# CERTIFICATE OF APPROPRIATENESS PLACARD

610 N BLOODWORTH STREET

113-14-MW

## Raleigh Historic Development Commission - Certificate of Appropriateness (COA) Application

## CL01

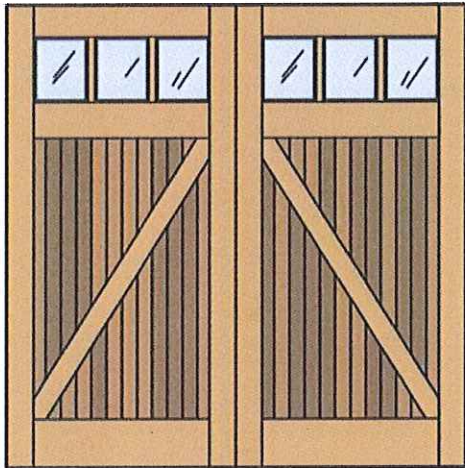
> · More information on the specifications for the garage door; the application says the materials are steel and composite, but the commission has only approved wood doors for historic garages

But I can confirm that the sidewalk will remain concrete as it is now, except for the bottom step; and We will substitute a wood garage door for the composite one. (see attached)

Email is fine! The revised garage door looks ok, but we still need the current photo of the front of the garage as it is now.
